Product Change Notification

Reference NO:	20220608_01
Product Classification:	IPCs
Date of Publication:	Jun.14 , 2022
Date of Change:	First batch: Jun/14/2022 Second batch: Jun/30/2022 Third batch: Aug/14/2022

The base depth of the listed cameras (refer the attachment) is increased to provide more room for camera cables

Change Before	Change After
 <p>Space depth for cabling 11.4mm</p>	 <p>Space depth for cabling 14.6mm</p>
 <p>Base height 35.5mm</p>	 <p>Base height 39.4mm</p>

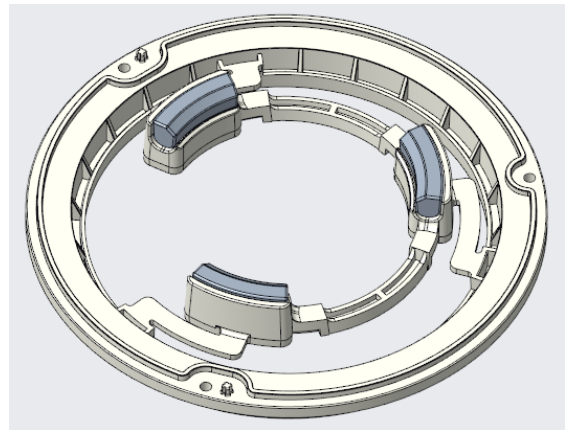
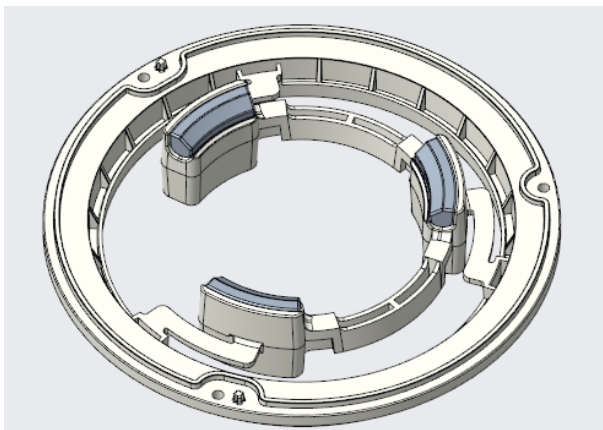
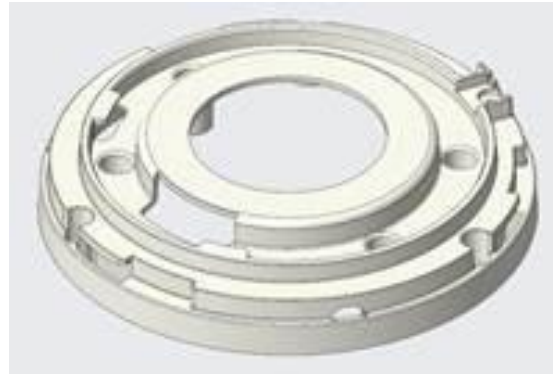
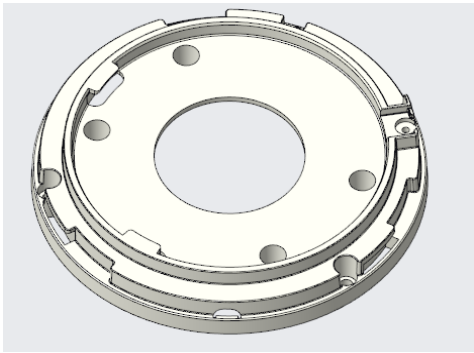
1. The space depth for cabling will be increased from 11.4mm to 14.6mm.
2. The base height will be increased from 35.5mm to 39.4mm
3. The new design is still compatible with current junction box;
